## **WSPA Comments on CEC DRAFT Transportation Fuels Assessment**

**RE: SB X1-2 Draft Transportation Fuels Assessment**

Thank you for the opportunity to comment on the California Energy Commission’s (CEC) “Draft Transportation Fuels Assessment” (CEC-200-2024-003-D), published on April 12, 2024, and the focus of the CEC workshop on May 3, 2024.

Figure 1 - CA Liquid Transportation Fuel Demand - "Slow Case"

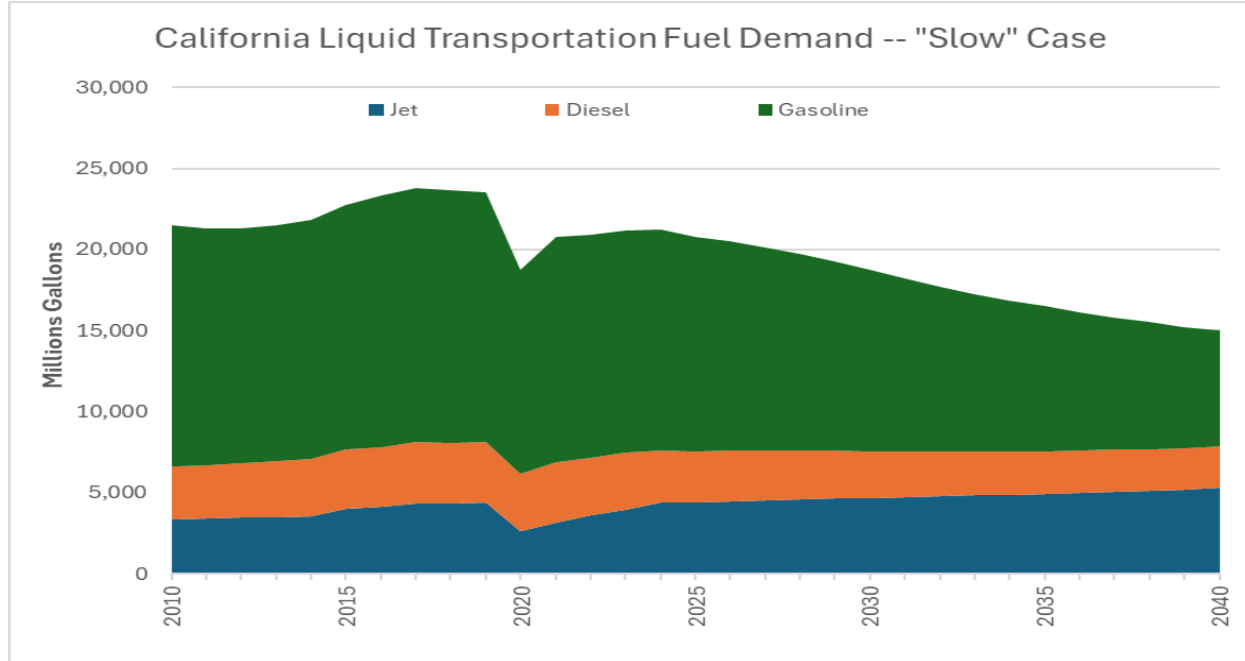
WSPA notes that the CEC had the resources in hand to include assessments for diesel and aviation fuel by using the same outlooks used for their gasoline assessment, as is reflected in the data presented in the 2023 Independent Energy Policy Report (IEPR).<sup>5</sup> Each of these fuel sources

were analyzed under “slow”, “fast”, and “rapid” scenarios, in which key assumptions about declines in demand were made based on the CEC’s demand modeling. To remind the CEC of its earlier published work, we include graphs from the 2023 IEPR report and from the modeling data submitted as supplemental to the CARB 2022 Scoping Plan Update.<sup>6</sup>

Figure 4 - Crude Oil Produced in California by Region

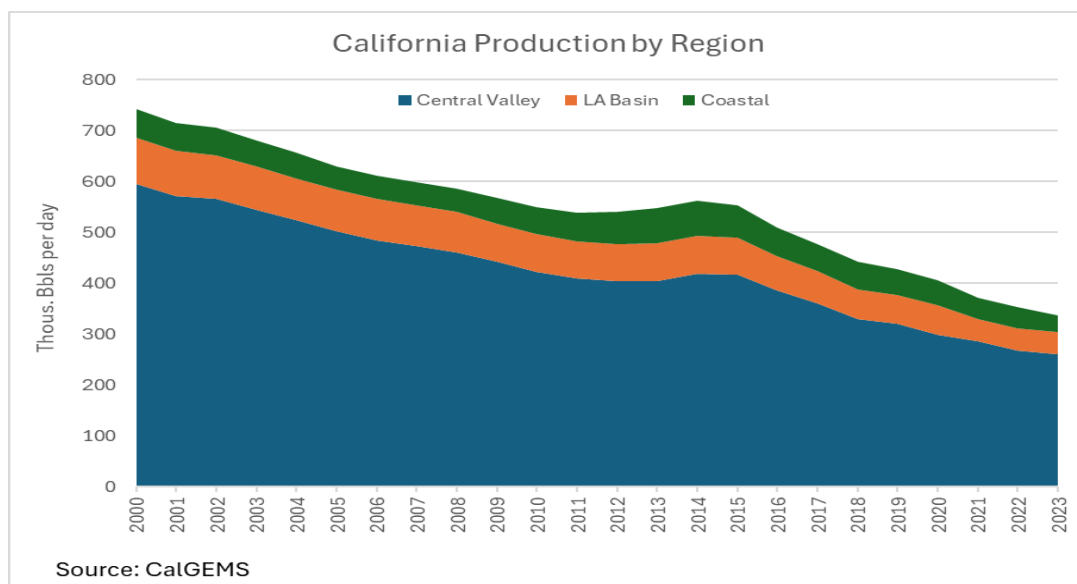
California crude oil production has declined at an average annual rate of 3.4% since 2000. The decline rate has been accelerating and was close to 14% in the second half of 2023. The decline in California domestic crude oil production has more to do with difficulties in obtaining permits to drill than lack of oil reserves. As of December 2022, California held almost 1.5 billion barrels of proved and probable crude oil reserves, which ranked it sixth among the 50 states.<sup>8</sup> The observable decline in production is not due to resource availability or the “natural decline” in production often cited in State reports. The actual decline in domestic oil production is due to highly constraining policies and a permitting environment with increasing barriers to oil and gas production. This is a more aggressive decline rate than was modeled in CARB’s 2022 Scoping Plan Update.<sup>9</sup> Constraints on domestic production have put substantial pressure on other parts of the system, including pipelines that transport crude oil to key refining locations in the State.

Figure 5 - CalGEM Oil and Gas Permits 2011-2024<sup>12</sup>

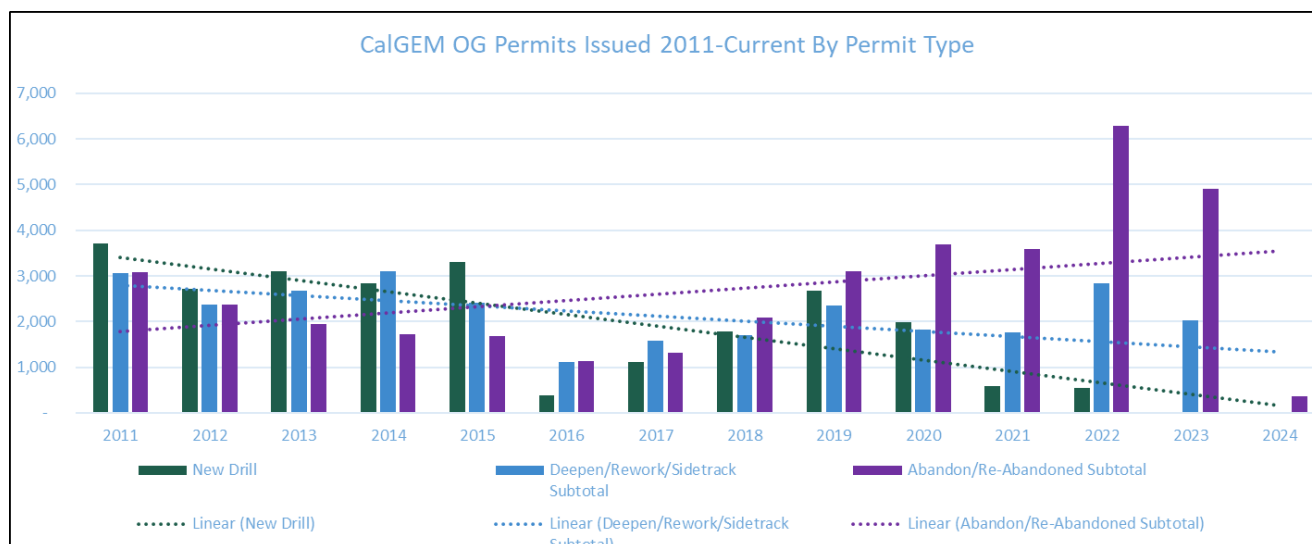
Figure 5 shows the decline in production-related permits approved since 2011. Historically, the agency has approved an average of 8,000-10,000 permits each year. Since 2019, the number of production-related permits has dropped to insignificance. The shift from production-related permitting to plugging and abandonment permits is dramatic, beginning with the upturn in global oil prices in 2017-18 and the increasingly politicized focus on shutting down and shutting-in production in California.

Figure 6 - Time to permit approval of oil and gas permits at CalGEM

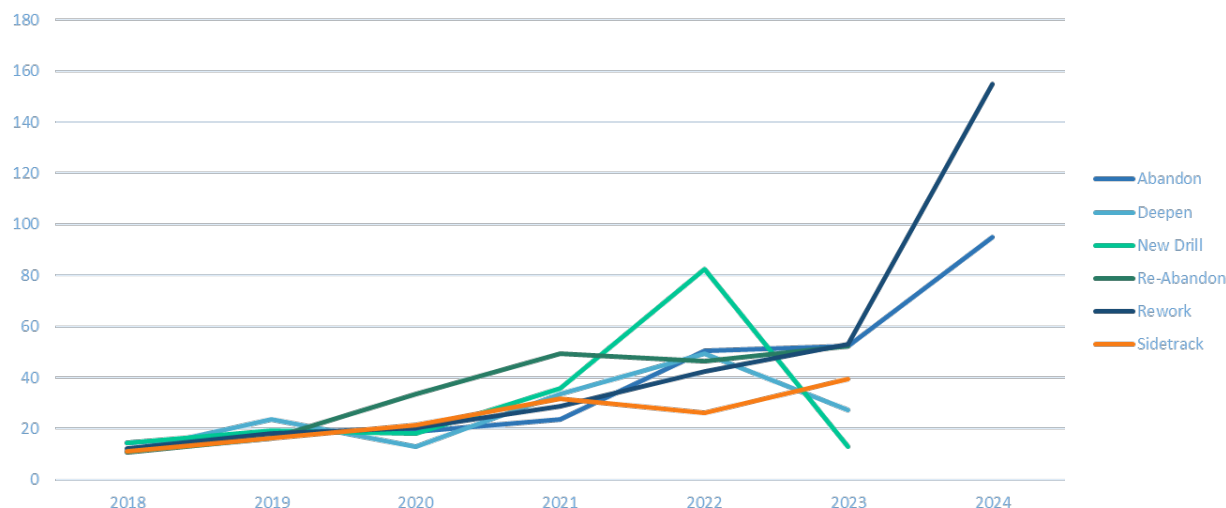
As a further impediment, the time that CalGEM takes to approve a production-related permit has expanded by over seven times in a mere five years, from an average of about 12 days to more than 185 days (see Figure 6, below). These are conditions that severely impact production in the state and explain a great deal of the decline in crude oil volume produced domestically.

Figure 7 - Location, alignment and carrying capacity of key crude oil pipeline infrastructure

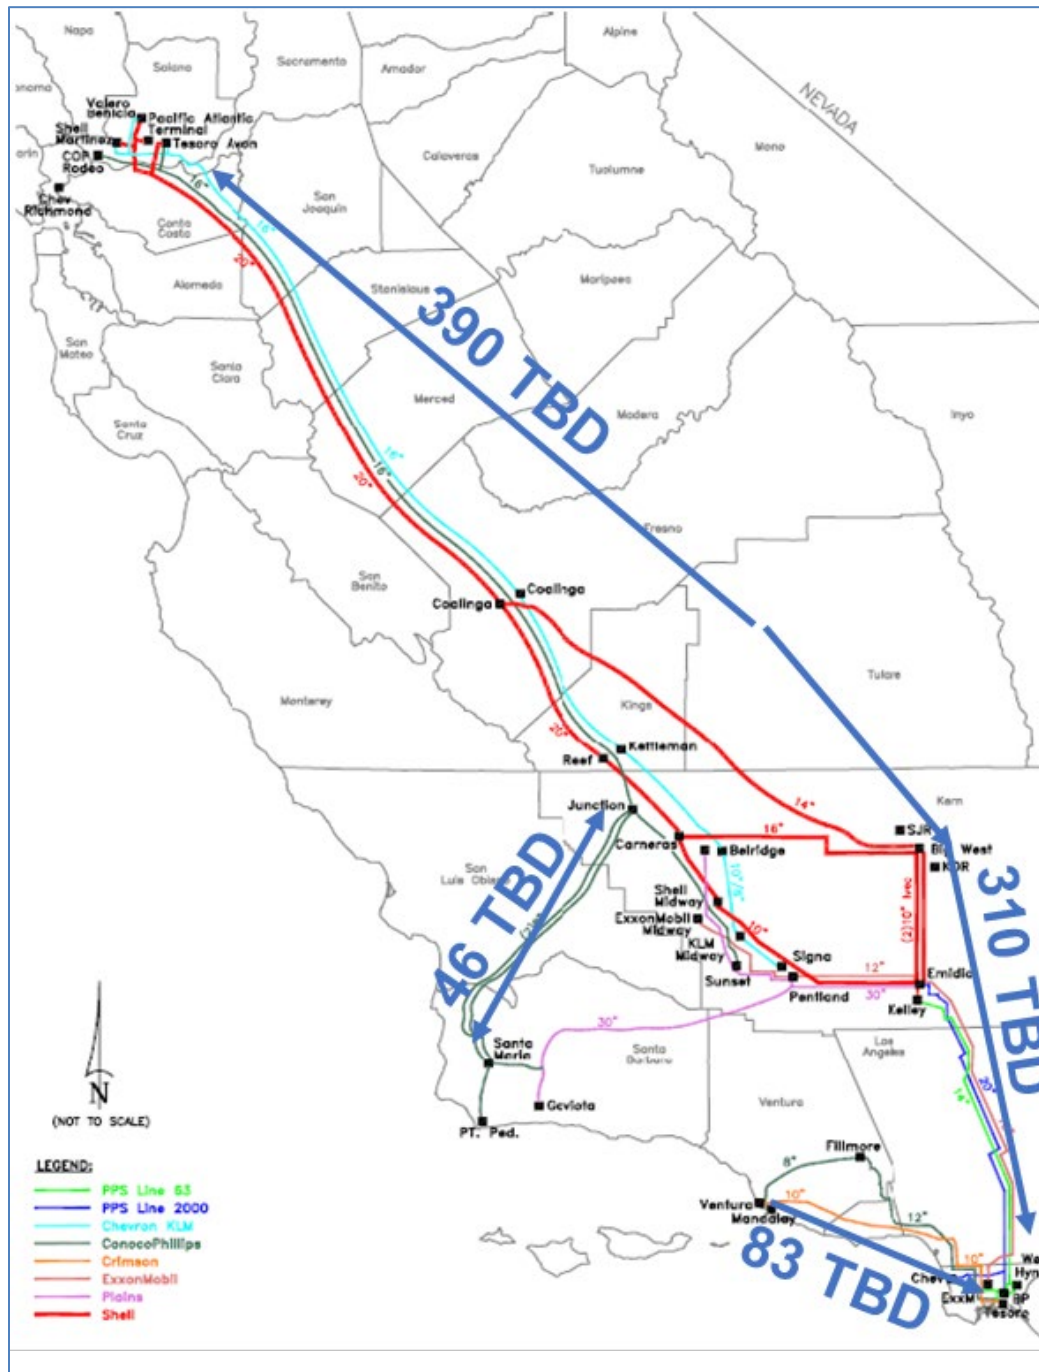
Figure 7 shows the alignment of several critical pipelines for crude oil and indicates their current design capacities. These design capacities were engineered with long-term production in view and took into account the reserves and likely future demand for transportation from oil fields to refineries dating from the 1980s onward.<sup>14</sup>

Each crude oil producing area is connected to a given refining center by multiple pipelines of various diameters (capacities). While this can be good for redundancy, in the event of an interruption, it also creates challenges in keeping the system operational as local oil production continues to decline. A pipeline must maintain some minimum volume so the crude oil will continue to move. This minimum throughput volume is a function of the pipeline’s design (e.g., diameter, length), operating conditions (e.g., pressure, temperature), geography (e.g., elevation changes), the age of the pipeline, the regulatory environment, and the characteristics of the crude oil itself

Figure 8 - Northern California Loads and Discharges (Vessels per Year)

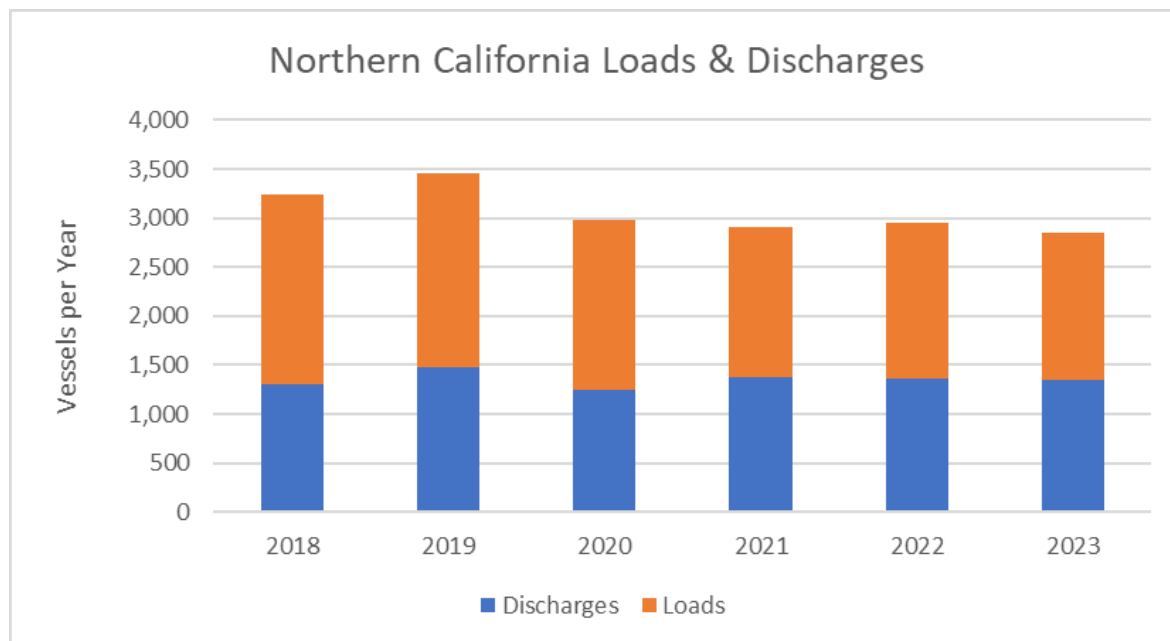
A vessel “discharge” occurs when a petroleum product or refinery feedstock is transferred from the marine vessel to onshore tankage. The vessel’s cargo may have originated from outside the state, another California marine terminal, or in some cases from a ship-to-ship transfer. Details are contained in the SLC datasets (e.g., if the vessel is a barge or ship and whether the ship is an international or Jones Act tanker). Since 2018, there has been a decline in the number of loads, but the number of discharges has remained fairly constant.

Most of the recent decline in loadings seen in Figure 8 has been fuel oil ships seen in Figure 9. What these data do not show are potential constraints to the marine logistics system. Those constraints can come in two forms: available dock space and regulatory constraints of the At-Berth Regulation, both of which we discuss below.

Figure 9 - Northern California Loads and Discharges – Crudes, Fuels and Oil Feedstocks, & Refined Products

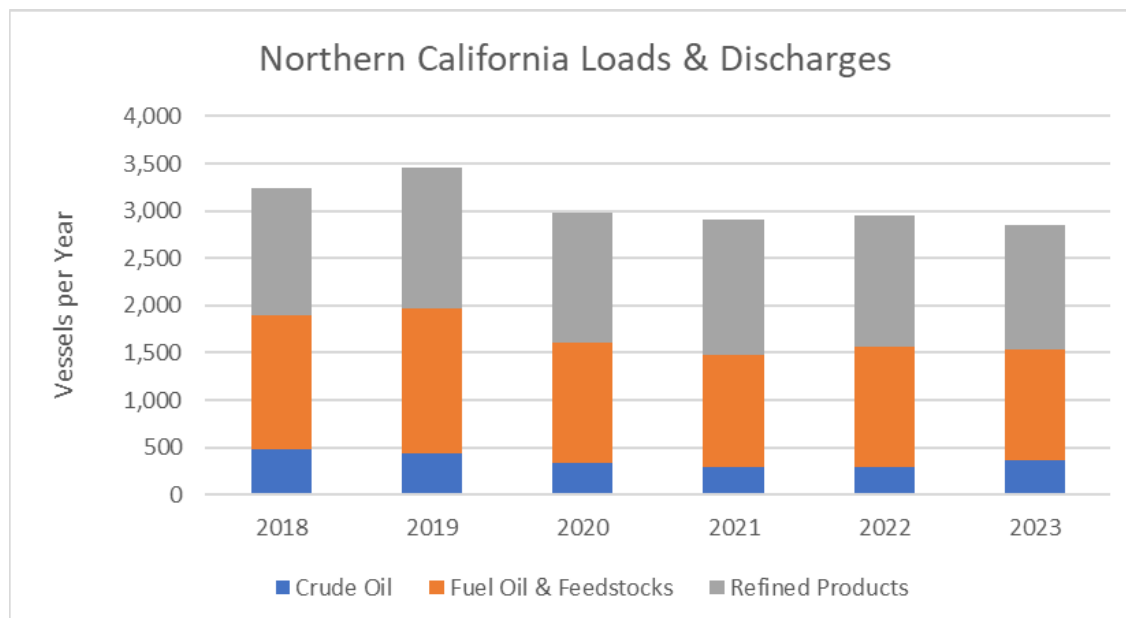
These data can also show what materials are moving across the docks. Figure 9 shows vessel movements in the North (i.e., San Francisco Bay Area) for crude oil, fuel oil and feedstocks, and refined products that consist of traditional transportation fuels (gasoline, diesel, and jet fuel) and
